Planning & Zoning Commission Regular Meeting AGENDA

Monday, January 13, 2020
Ketchum City Hall
480 East Avenue North, Ketchum, ID 83340

STAFF REPORT
KETCHUM PLANNING AND ZONING COMMISSION
REGULAR MEETING OF JANUARY 13, 2019

Illustration A:

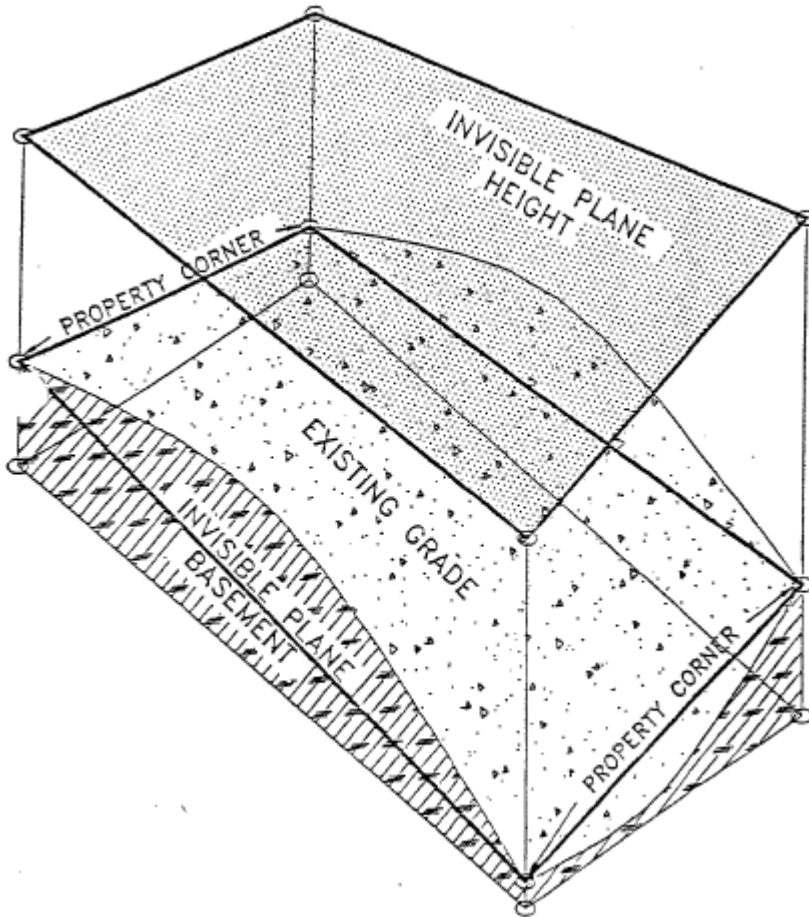
Consistent with Illustration A and city definitions, as set forth in KMC §17.08.020, the 10th Street garage/light industrial unit is a basement.

A2.0

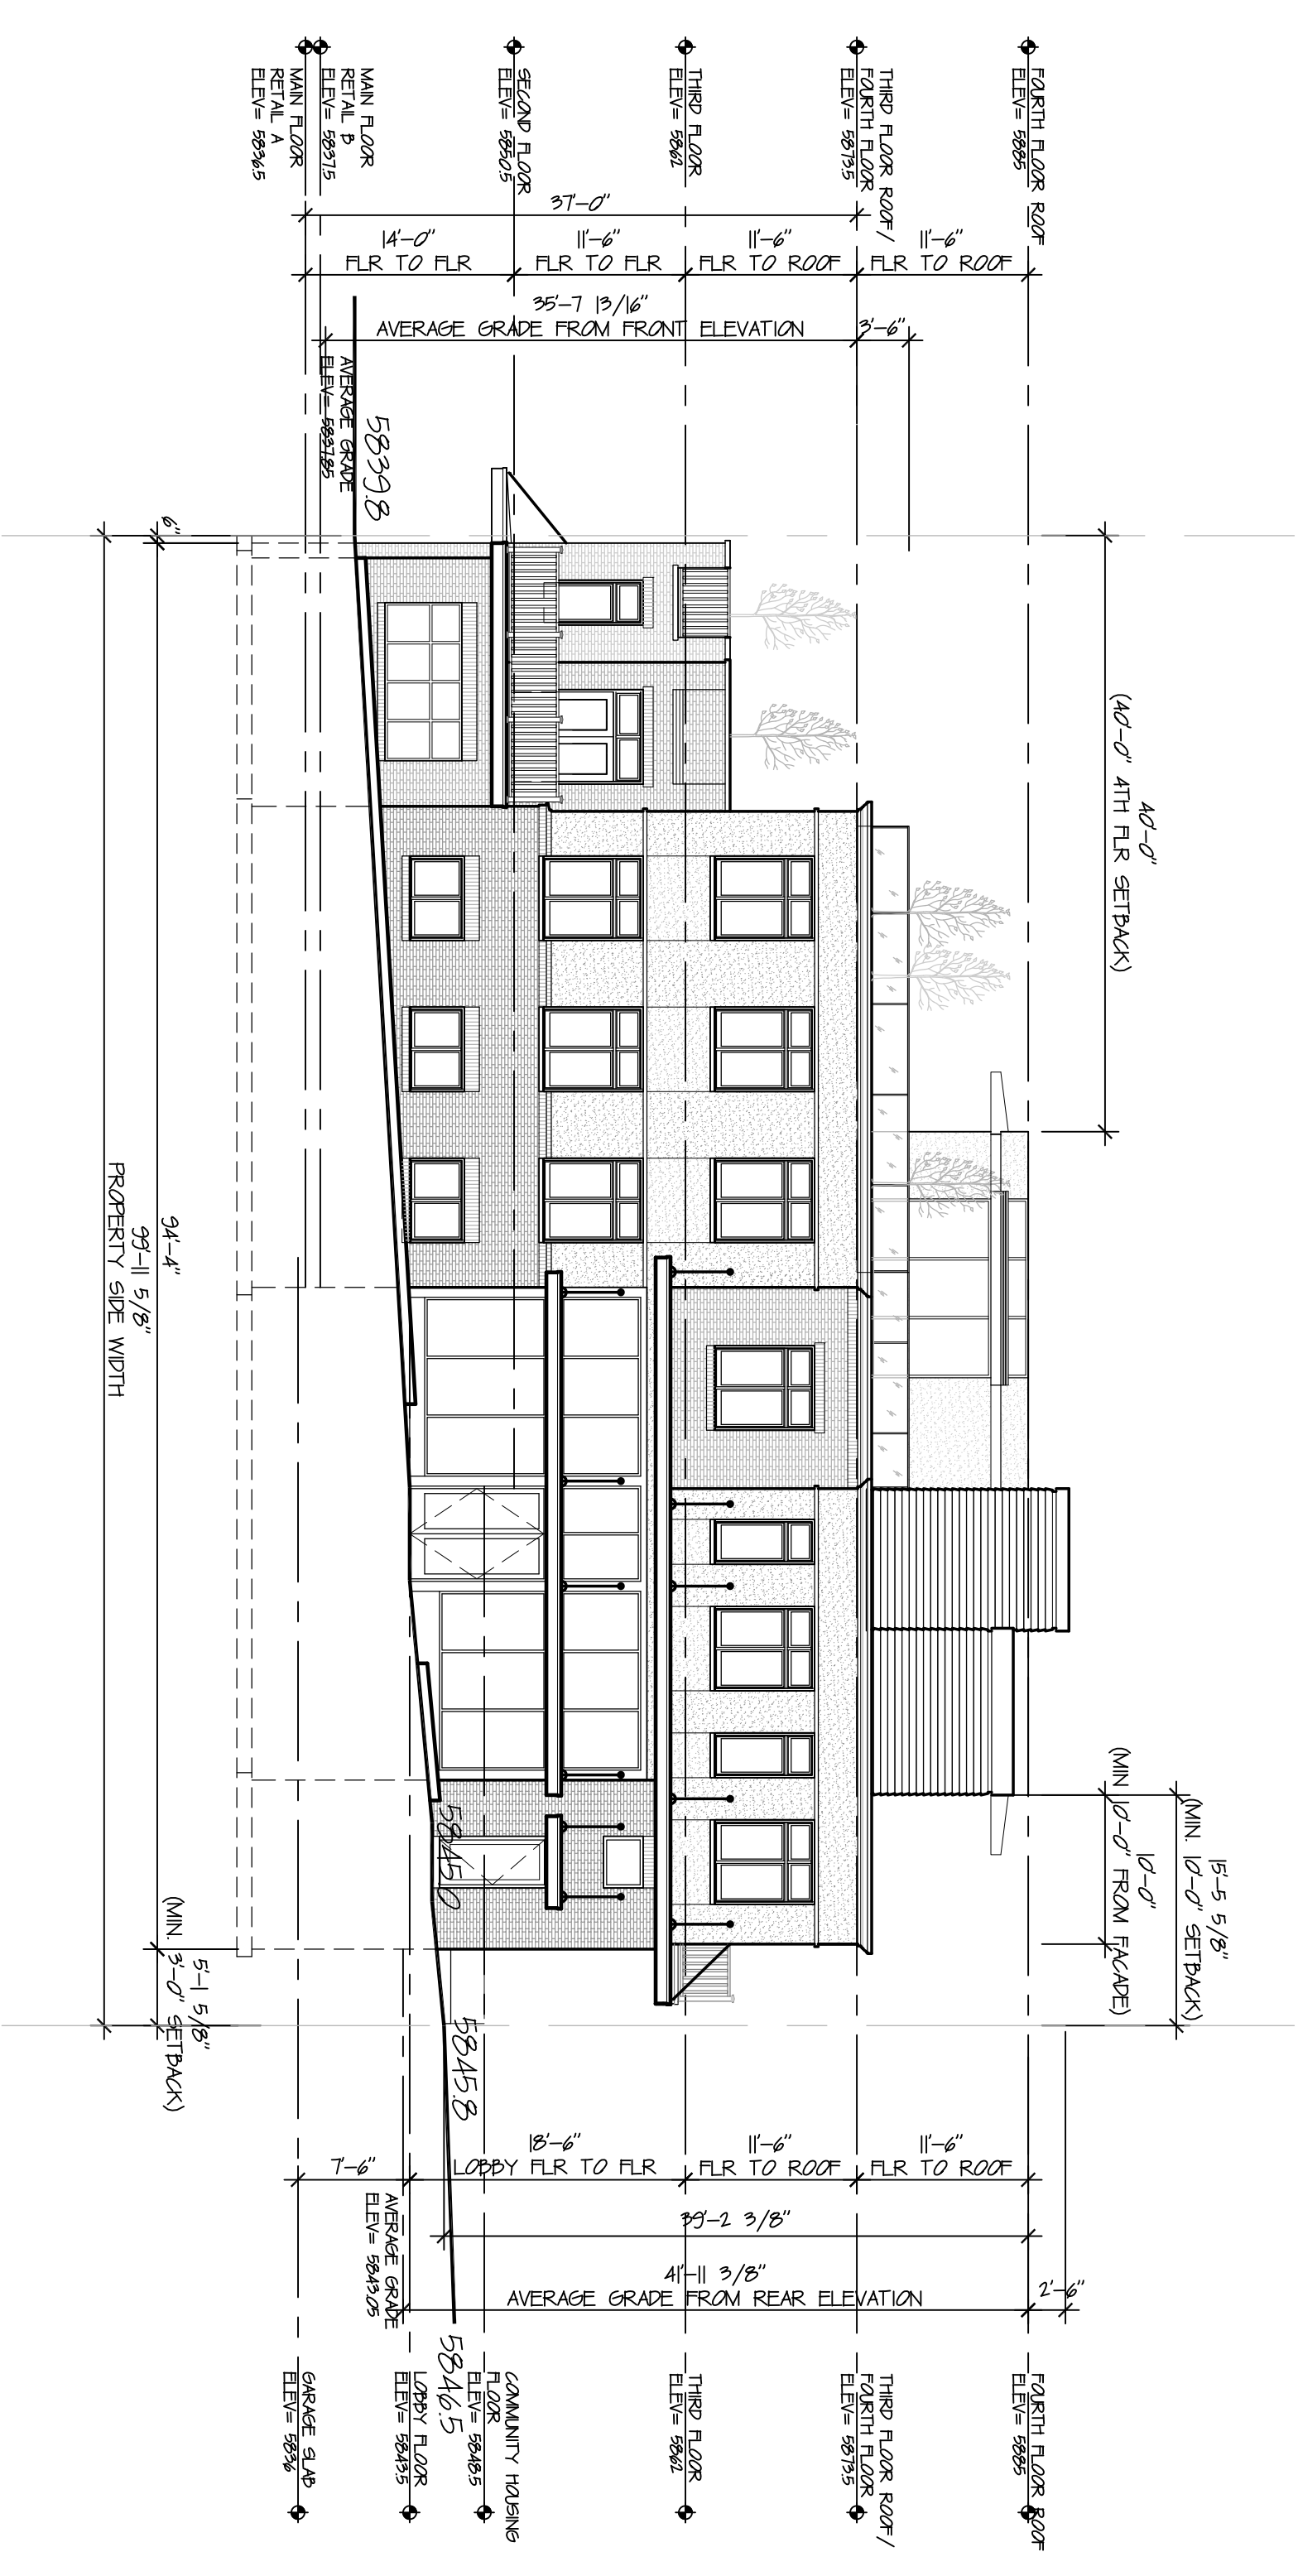
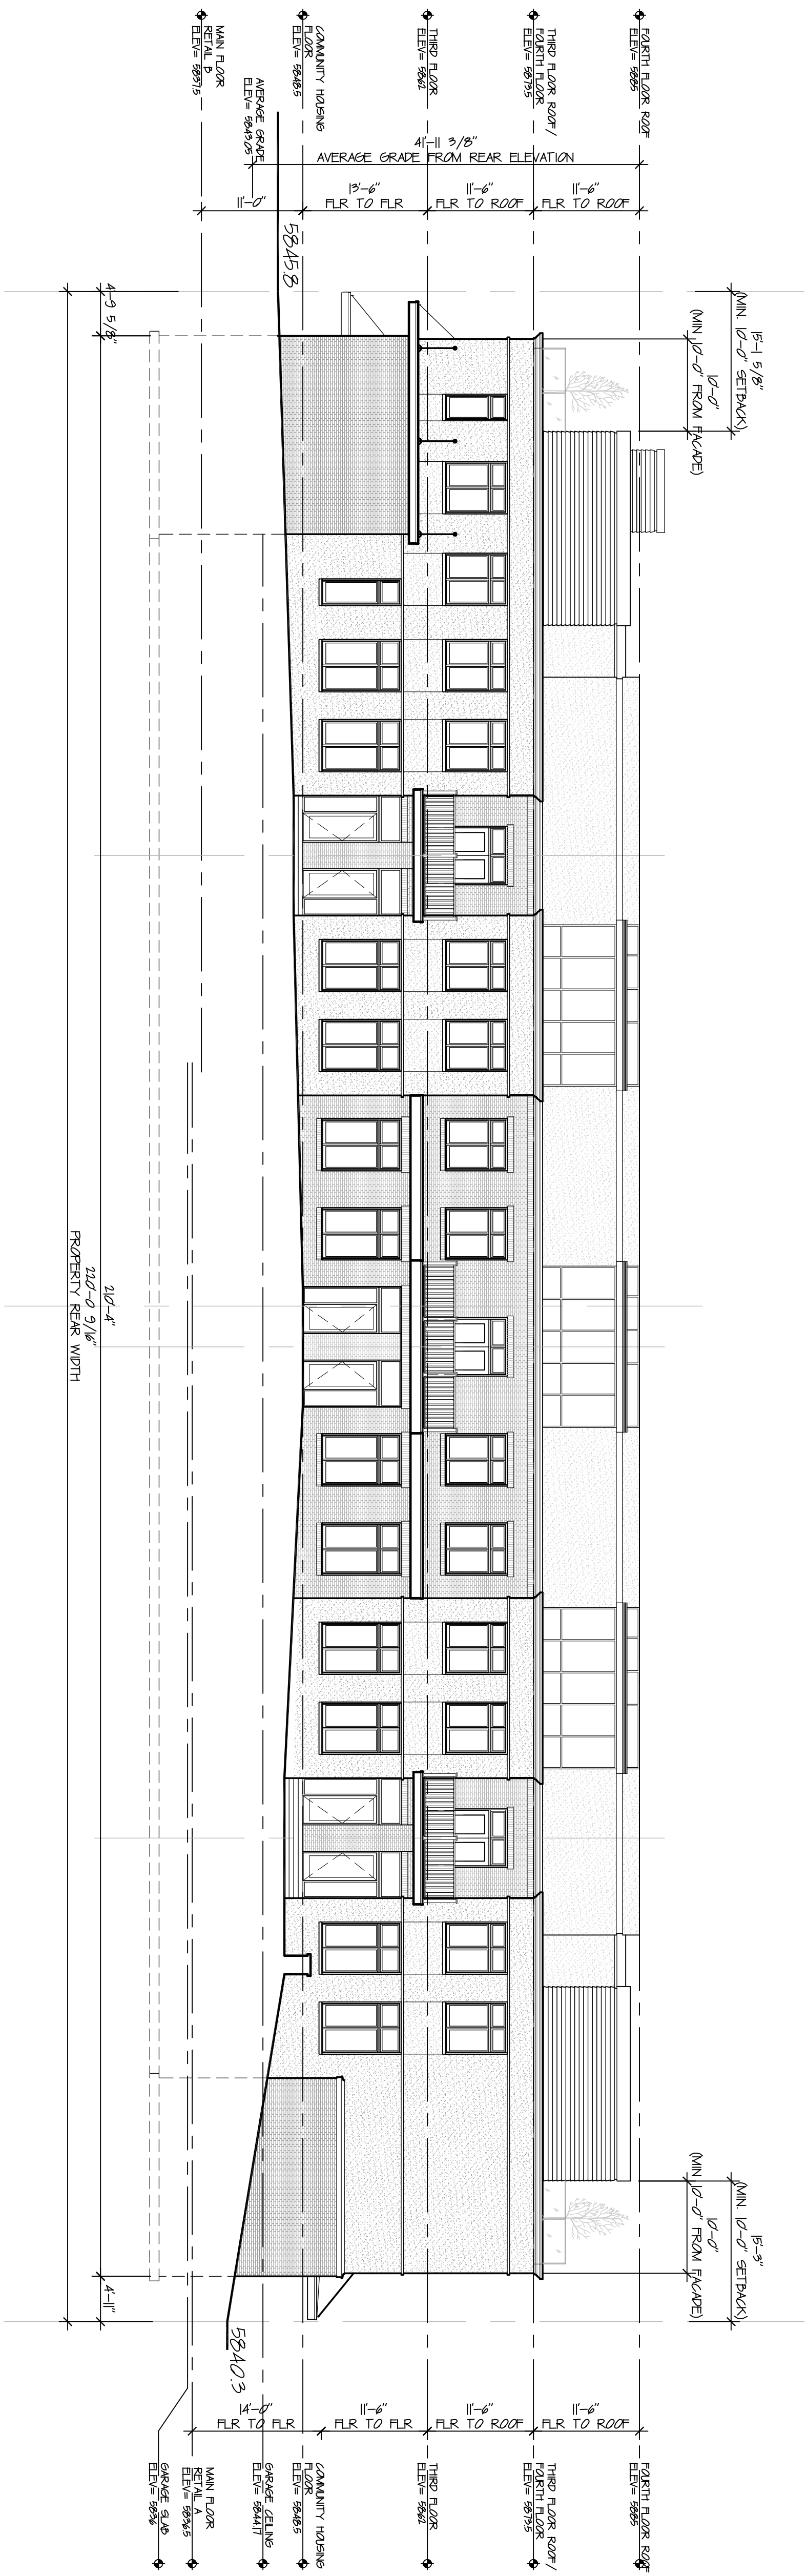
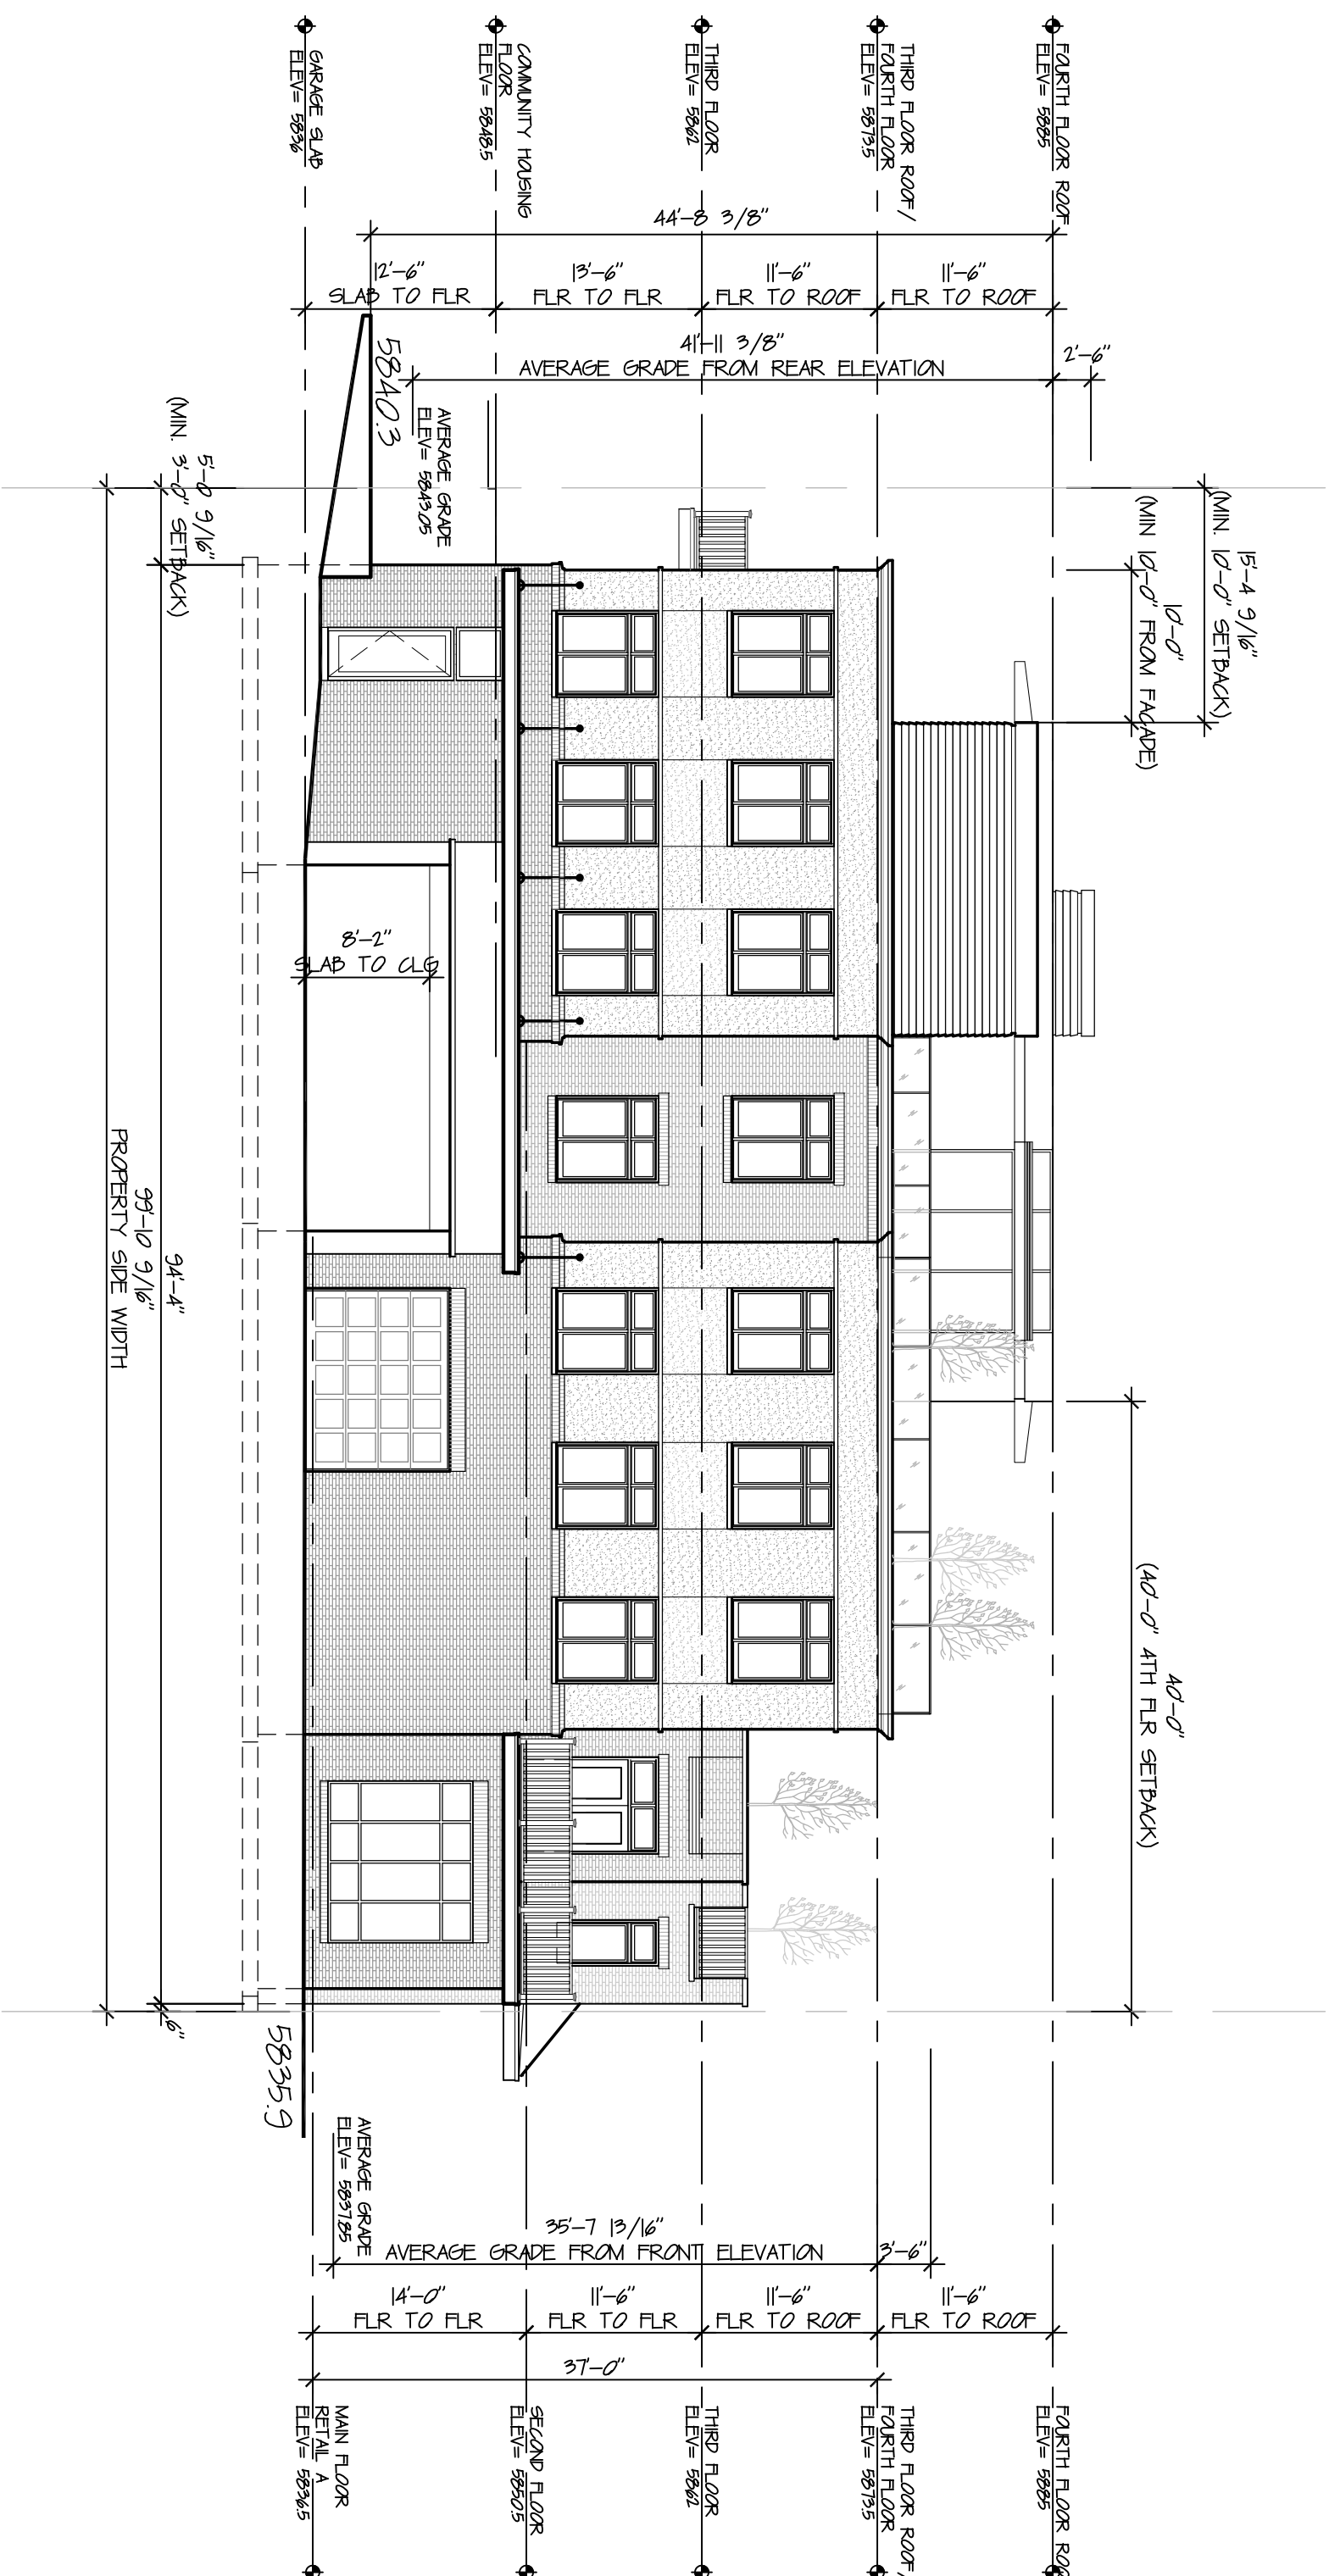
As indicated on Sheets A2.0 and A2.1 of the drawings, the maximum building height from the average front elevation is 35’-8” and the maximum building height from the average rear elevation is 41’-11”. The maximum building height from the front average elevation (5837.5’) to the fourth-floor roof (5885’) is 47.5’. The length of the front façade spans 210’-4” along Main Street. While the retail-space entryways are recessed (Sheet A1.0), the design of the front façade requires more articulation to reduce the flat mass of the vertical wall plane (Sheet A2.0).
